HUMAN FACTORS ASSESSMENT: M9 ARMORED COMBAT EARTHMOVER (ACE)

REPORT DOCUMENTATION PAGE		READ INSTRUCTIONS BEFORE COMPLETING FORM																
1. REPORT NUMBER ARI Research Note 88-12	2. GOVT ACCESSION NO.	3. RECIPIENT'S CATALOG NUMBER																
4. TITLE (and Subtitle) Human Factors Assessment: M9 Armored Combat Earthmover (ACE)		5. TYPE OF REPORT & PERIOD COVERED Final Report February 1983 - December 1985																
7. AUTHOR(s) Gregory S. Krohn		6. PERFORMING ORG. REPORT NUMBER																
9. PERFORMING ORGANIZATION NAME AND ADDRESS Essex Corporation 333 North Fairfax Street Alexandria, VA 22314		8. CONTRACT OR GRANT NUMBER(s) MDA 903-83-C-0033																
11. CONTROLLING OFFICE NAME AND ADDRESS U.S. Army Research Institute for the Behavioral and Social Sciences, 5001 Eisenhower Avenue, Alexandria, VA 22333-5600		10. PROGRAM ELEMENT, PROJECT, TASK AREA & WORK UNIT NUMBERS 2Q263739A793																
14. MONITORING AGENCY NAME & ADDRESS (if different from Controlling Office) - -		12. REPORT DATE April 1988																
		13. NUMBER OF PAGES 185																
		15. SECURITY CLASS. (of this report) Unclassified																
		15a. DECLASSIFICATION/DOWN

Figure 4. Locations of the major human factors engineering deficiencies and safety hazards found on the M9 ACE. The drawings are from the Operator's Manual, Armored Combat Earthmover (ACE), M9 (TM 5-2350-262-10), Headquarters, Department of the Army, February 1984.

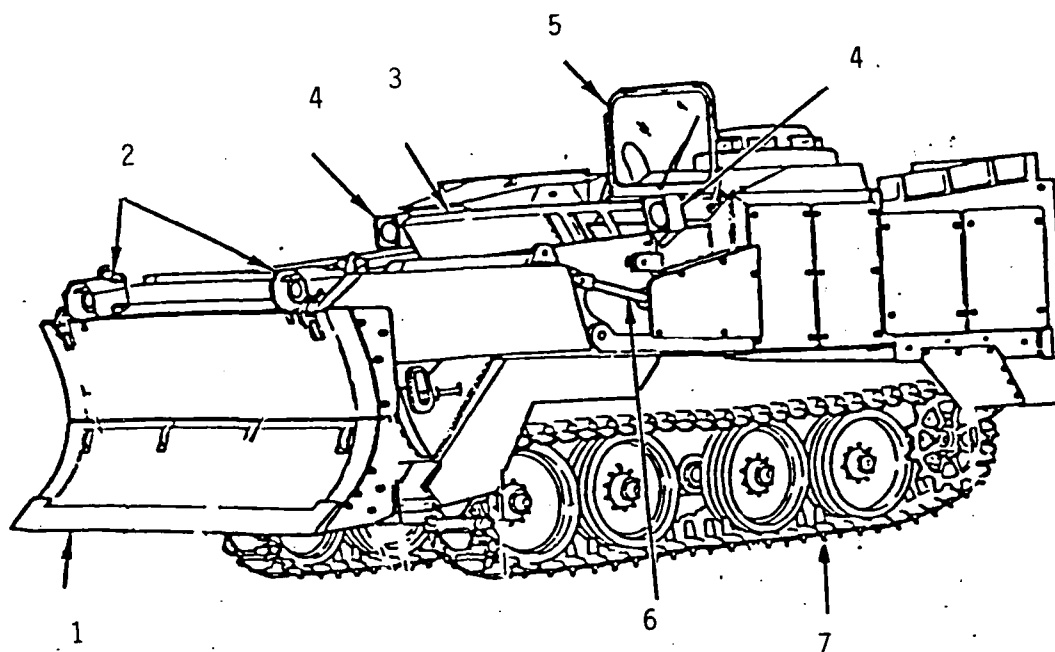
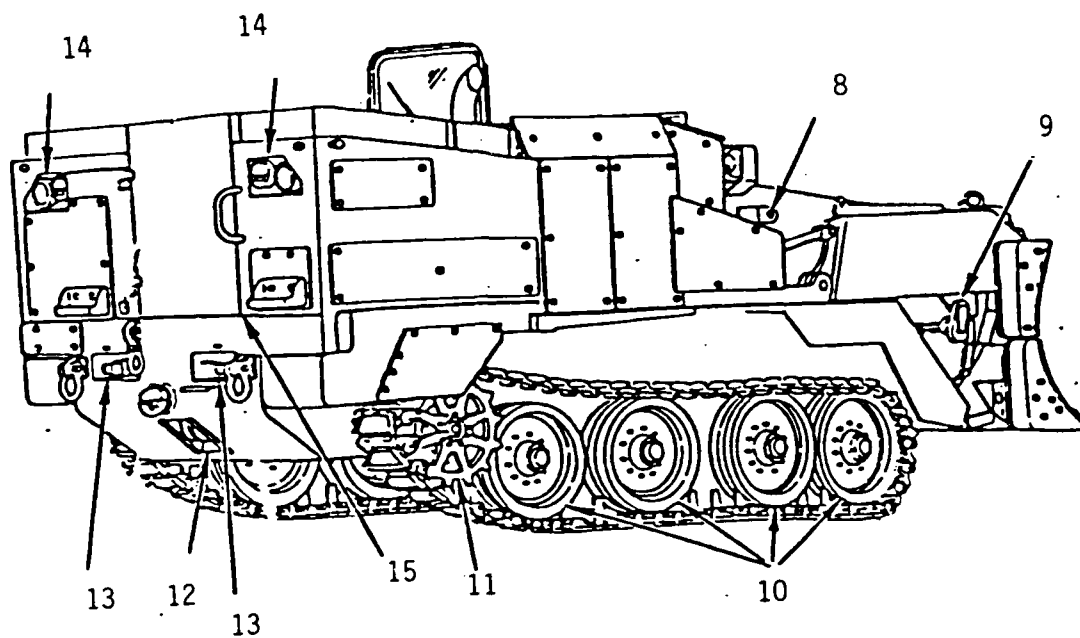
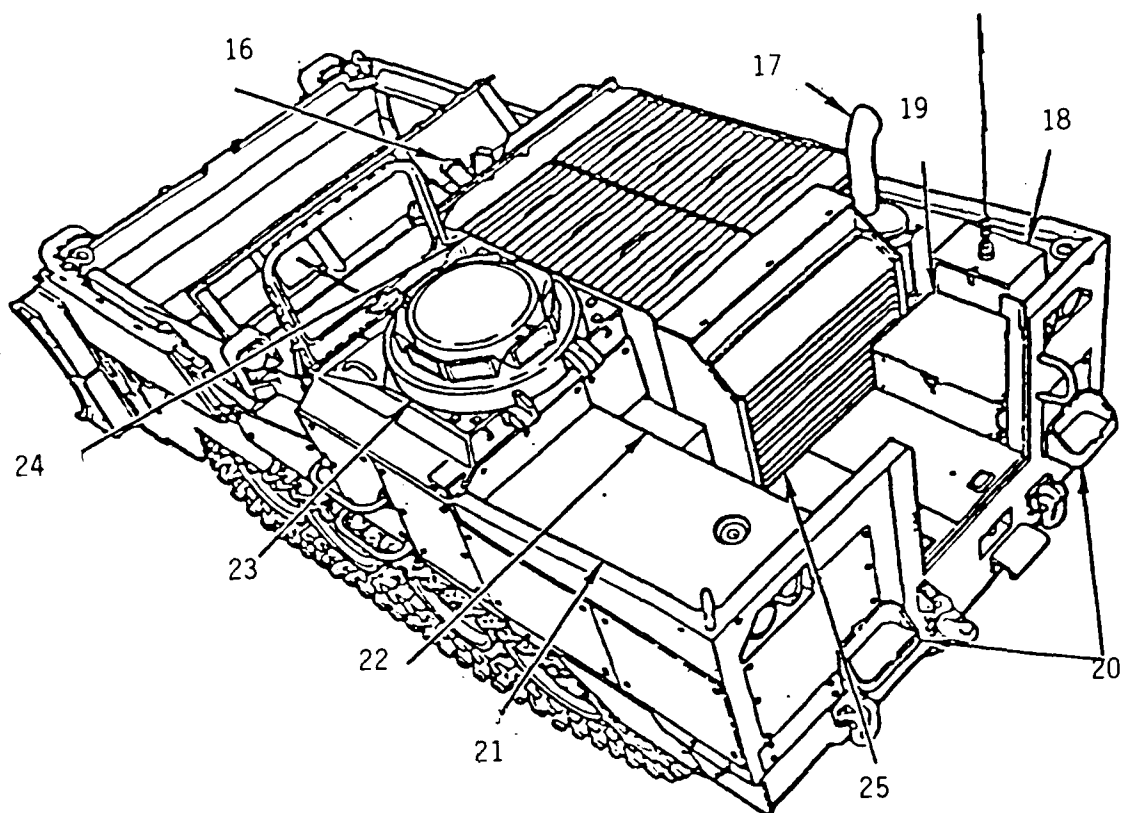
Figure 4 shows the location of the major human factors engineering deficiencies and safety hazards found on the M9 ACE. The deficiencies and hazards are described in the sections that follow for M9 operations and M9 maintenance. Categories such as a description of the deficiency (or safety hazard), the implications for the operator and the equipment, other affected tasks and equipment functions, and potential solutions are used to organize the information.

1. APRON AND DOZER ASSEMBLY. The operator must unsafely crawl beneath the dozer blade in order to prepare it for folding.
2. HEADLIGHTS. The lights do not conform to the Army Secure Lighting Program.
3. EJECTOR. There is no ejector blade lockout device to prevent its being retracted when personnel work in the bowl. The ejector cylinder (not shown) must be removed before other major components can be removed.
4. FLOODLIGHTS. The lights are frequently broken by collisions with trees.
5. WINDSHIELD. The windshield is frequently broken by collisions with trees.
6. APRON CYLINDER. The lubrication points are blocked by an armor panel.
7. TRACK. The track pads frequently wore out and may have increased vehicle vibration.

8. UPPER APRON LOCK PINS. Pin openings must be perfectly aligned in order to insert the pin. Two people are required to perform the task.
9. LOWER APRON LOCK PIN. The pins were difficult to remove due to the tightness of their fit. The pins were deformed by operators hammering them in and out of position.
10. ROADWHEELS. Rubber broke off the roadwheels and may have increased vehicle vibration. Roadwheels are hazardous to remove and replace.
11. FINAL DRIVES. The final drives must be drained in order to check the fluid levels.
12. WINCH ASSEMBLY. The winch is under capacity. The wire rope broke frequently. The wire rope wraps unevenly on the drum. There is no winch brake.
13. REAR STEP. The step was crushed in collisions.
14. TAILLIGHTS. The lights do not conform to the Army Secure Lighting Program.
15. REAR DOOR. The door is difficult to lift when installing or stowing it.

16. SMOKE GRENADE LAUNCHERS. The launchers are difficult to load from the sloped roof of the engine housing.
17. MUFFLER. Debris trapped in the muffler well was caught on fire. The radio cables were burned by heat generated from the muffler.

Figure 18. The damage to the rear of the vehicle. (The winch cable, the rear steps, the jerry can holders, and the handrails are broken.)

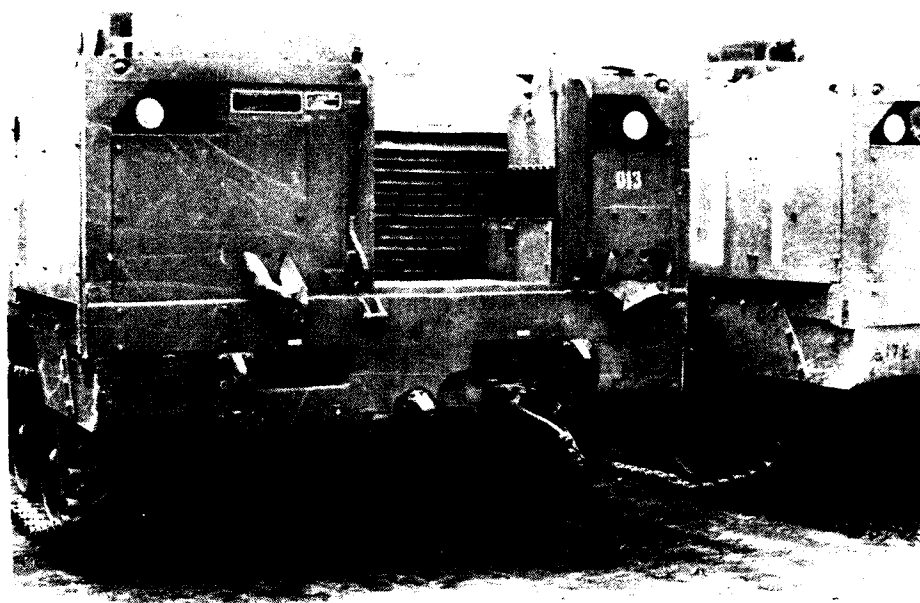
Description of the Deficiency: Table 17 lists the number of operators responding to questions concerning the space provided for stowage and its locations. Figure 18 shows damage to jerry can holders and other objects on the rear of the vehicle. Table 18 lists the specific stowage deficiencies for basic issue items (BII) and other equipment.

Implications for the Operator and the Equipment: Stowed equipment on the rear of the vehicle was frequently damaged by collisions with objects to the rear of the vehicle. Stowed equipment on the rear deck of the vehicle was affected by the high engine temperature. The stowed equipment blocked the air flow and affected the efficiency of the cooling system. Stowage locations that are difficult to access increase the time it

Potential Solutions: The Final Report of the First Article-Initial Production Test (1984) recommended a complete review of the stowage space provided on the M9 ACE and its load plan. In addition to a complete review, several specific recommendations include:

1. Add a rear bumper that extends along the lower rear of the M9 and up both of the outside edges. The bumper should be wider than any of the stowed items kept at the rear of the vehicle and the outside edges should be wide enough to deflect tree limbs. The rear bumper could also include an improved rear step and mount for the winch.

2. Increase the length and depth of the OMV tool box to accommodate the additional equipment (ie., the tanker bar, life jacket, canvas canopy, etc.).
3. Add steps and handholds to assist operators when climbing into the bowl in order to make access to the tool box easier and safer.

4. Add a mechanism on the tool box lid to lock it open and to avoid having it fall on the operator.
5. Add stowage compartments on the rear of the vehicle and protect them from being crushed.

Figure 30. Damage to the floodlight guard

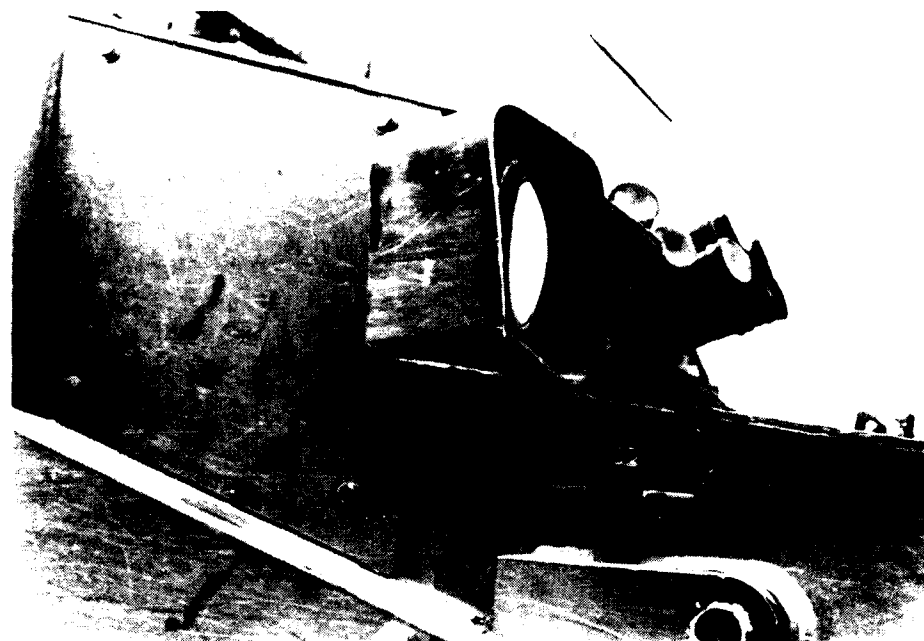
Description of the Deficiency: Figure 30 shows a damaged protective shield for a floodlight mounted on the side of the vehicle. The side mounted floodlights were frequently damaged by collisions with trees.

1. Place the side mounted floodlights in protected locations more inboard on the vehicle than the present locations. Perhaps, floodlights could be located inboard at a greater height on a removable stand or fixture.
2. Add lights meeting the requirements of the Army Secure Lighting Program.

Figure 31. The red filtered and high intensity white filament lights at the rear of the vehicle.

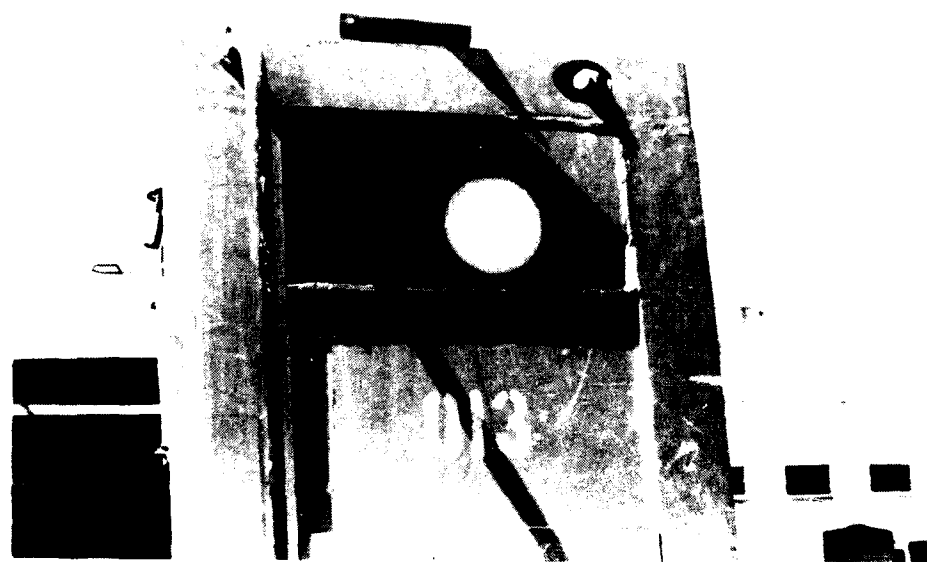
Figure 31 shows the operating lights at the rear of the vehicle. The operating white lights and red filtered lights do not conform to the Army Secure Lighting Program. The program requires blue-green low energy lights in addition to other requirements.

Figure 33. Mechanic grasping the paddle lock bracket to open the hatch. (The night vision periscope is in place above the driver's hatch.)

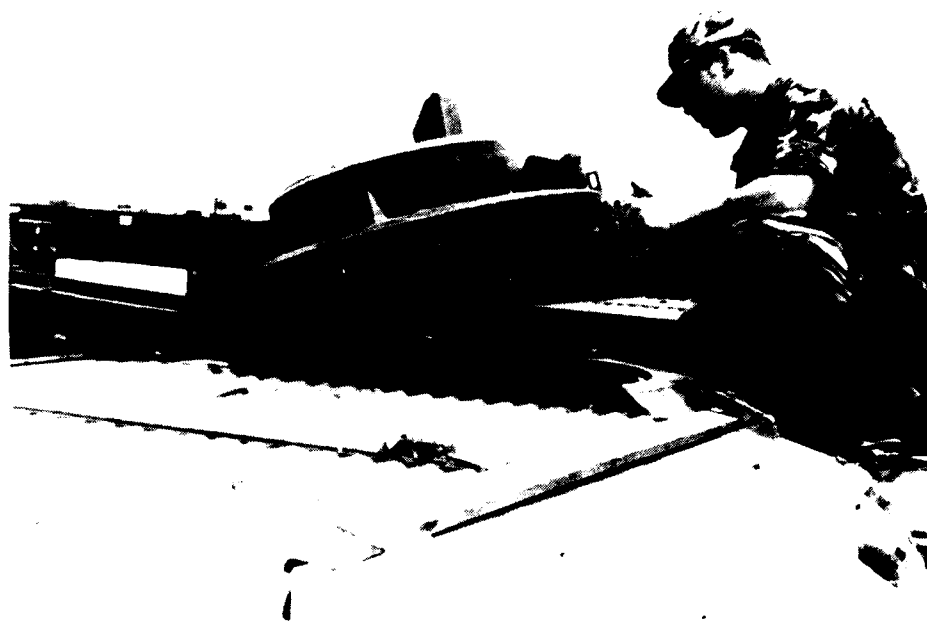
4. Figure 33 shows a mechanic grasping the bracket of the hatch paddle lock. There is no easy way to grasp the hatch in order to open it.
5. Figure 34 shows personal combat gear stowed in the driver's hatch (see Deficiency: Insufficient Stowage Space and Secure Locations for Stowage, pg 49). Using the hatch for stowage adds to the time required to close the hatch in a combat emergency or before firing the smoke grenade launcher.

1. The weight of the hatch should be reduced, or opening and closing the hatch should be mechanically assisted, so that the force exerted by the operator to perform the task is within the limits required by MIL-STD-1472C.
2. The hatch should be opened with a single motion of the hand and arm (MIL-STD-1472C).
3. The vision blocks and other structures in the hatch, or the roof surrounding the hatch, should be positioned far enough from the operators so that their faces cannot strike the objects when they are seated and wearing their seat belts properly.
4. Handholds should be added inside and outside of the hatch to facilitate opening and closing the hatch.
5. The hatch should be sealed when closed to prevent leaks of water or NBC contaminants.

Figure 37. An operator attaching the chain to the ejector blade and positioning it down the center of the dozer blade. (NOTE: The chain passes through the stowage area above the dozer blade.)

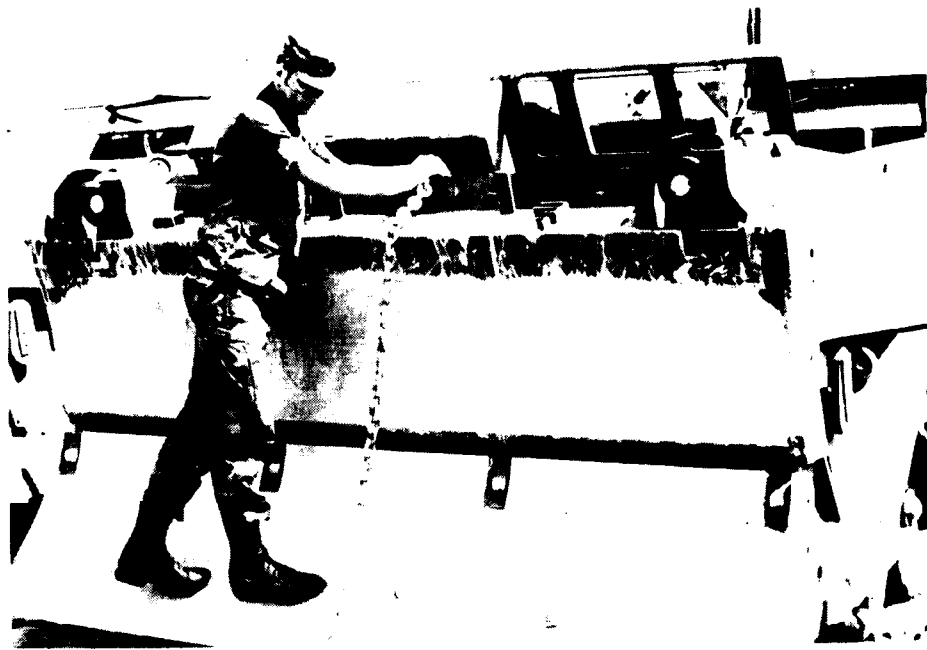
Description of the Safety Hazard: Two operators reported that folding the dozer blade was hazardous. Figure 36 shows an operator crawling beneath the dozer blade in order to attach a chain to a shackle beneath the blade. The vehicle suspension must be raised (sprung) and supported with blocks in order to prevent the dozer blade from descending on the operator as a result of pressure changes in the hydraulic system. The support blocks were unavailable in the field and earth berms, which could collapse, were used to support the dozer blade.

An alternative to the procedures involves raising the apron and dozer blade allowing the operator to stand beneath the dozer blade to attach the chain. However, the additional steps add approximately 15 minutes to the 20 to 30 minutes procedure. The additional time results from removing and replacing the apron pins (see Deficiency: Apron and Dozer Blade Lock Pins, pg 64). Moreover, unless the apron is fully raised and locked with its safety pins (making the shackle difficult to reach) the dozer blade and apron could fall on the operator, again as a result of pressure changes in the hydraulic system.

Figure 39. The crushed rear step and handrail.

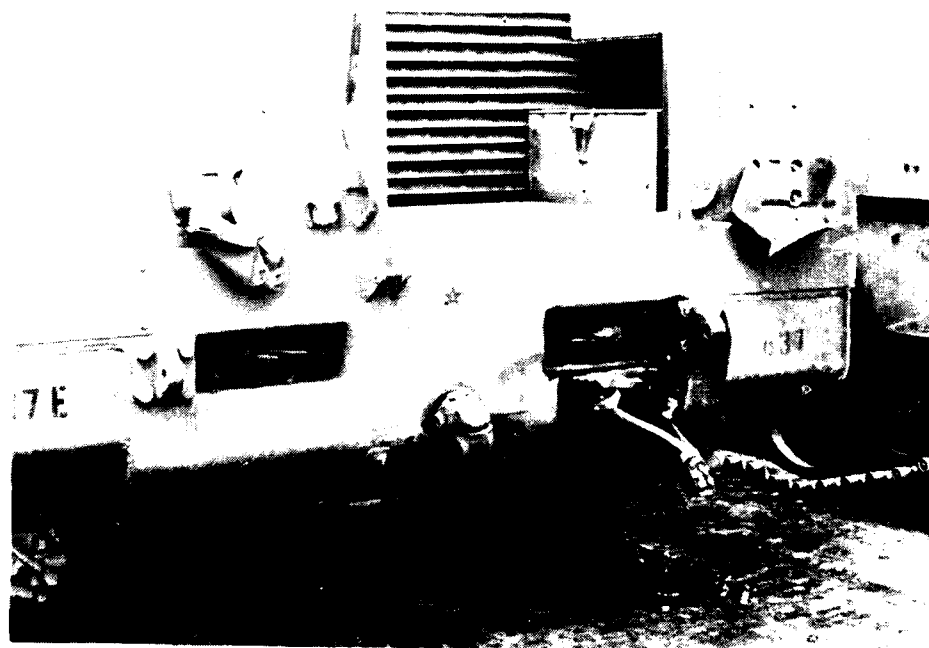
Description of the Safety Hazard: Figure 39 shows the crushed rear steps and handrails on the rear of the M9. The rear lower cable step snagged on objects and the cables and steps were broken. The rear upper platform step was crushed on all the vehicles. The handrails were bent on many of the vehicles. Scraped metal on the handrails had burrs that would stab the operator's hand.

1. The radiator housing. Figure 40 shows an operator trying to step down from the radiator housing.
2. The smoke grenade launcher area including the sloped deck above the tool box.
3. The right and left apron cylinder areas used by personnel to enter or exit the bowl. Figure 41 shows an operator climbing up by the apron cylinder in order to see into the bowl.

Figure 42. The eight engine grille panels.

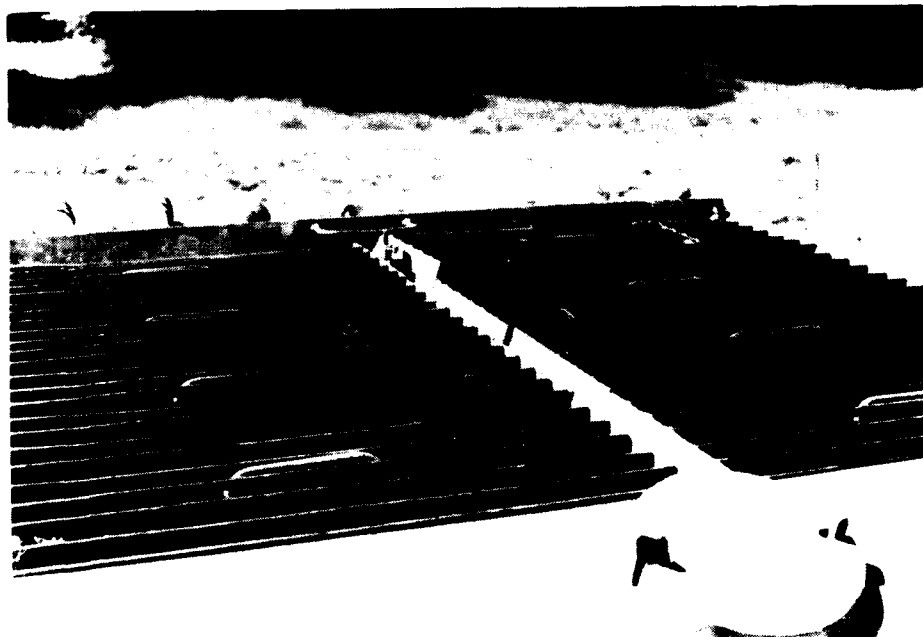
Description of the Safety Hazard: Figure 42 shows the eight engine access grilles in place above the engine. Three mechanics and four operators reported that the weight of the exhaust grilles (approximately 50 lbs (22.6 kg)) discouraged the operators from performing PMCS checks. Moreover, there is no safe way to stand above the grilles to remove them as the surfaces in front and to the rear of the grilles are sloped and slippery (safety hazard).

1. Reduce the weight of the grilles. Use a lighter material for the grilles other than steel (ie., aluminum).
2. Make the grille sections into one piece that is hinged and can be raised and supported like the hood of a truck.

Figure 43. A damaged winch cable and the cable unevenly wrapped on the winch drum.

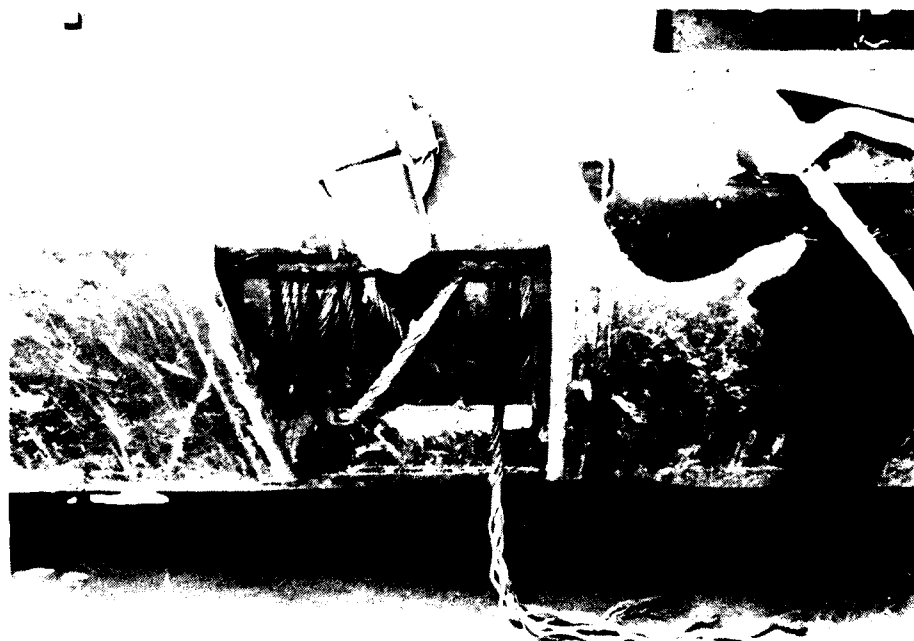
Description of the Safety Hazard: Figure 43 shows a frayed and broken winch cable improperly wrapped on the winch spool. Operators experienced several problems using the winch and many problems resulted in wire rope failure. The problems included:

1. There was no winch brake on the winch.
2. The winch had to be moving in order to shift gears.
3. The winch capacity is only 30,000 lbs, while the vehicle weighs approximately 55,000 lbs, when the bowl is full and the vehicle is likely to become stuck. Most of the wire rope failures occurred during self-recovery operations.
4. The wire rope wrapped itself unevenly on the drum which causes damage to the wire rope. The operators could not see whether the wire rope was wrapped appropriately as the winch was spooling it in.

Implications for the Operator and the Equipment: The winch is under capacity for most self-recovery operations. Often another M9 would use its winch in combination with the winch on the stuck M9 (double winching), yet cables broke when the double winching method was used. The depth of mud in which the M9 is mired doubles or triples the weight capacity required of the winch in order to pull the mired vehicles (FM 17-20). Thus, a winch capacity of 30,000 lbs is insufficient for a combat loaded M9 weighing 34,800 lbs with its bowl empty and mired up to its hull (a depth of mire that doubles the weight factor of the vehicle by friction and suction to approximately 68,000 lbs). Shackles and snatch blocks can be used to increase the mechanical advantage of the winch by folding the wire rope. However, shackles and snatch blocks limit the length the wire rope can be extended (refer to FM 17-20).
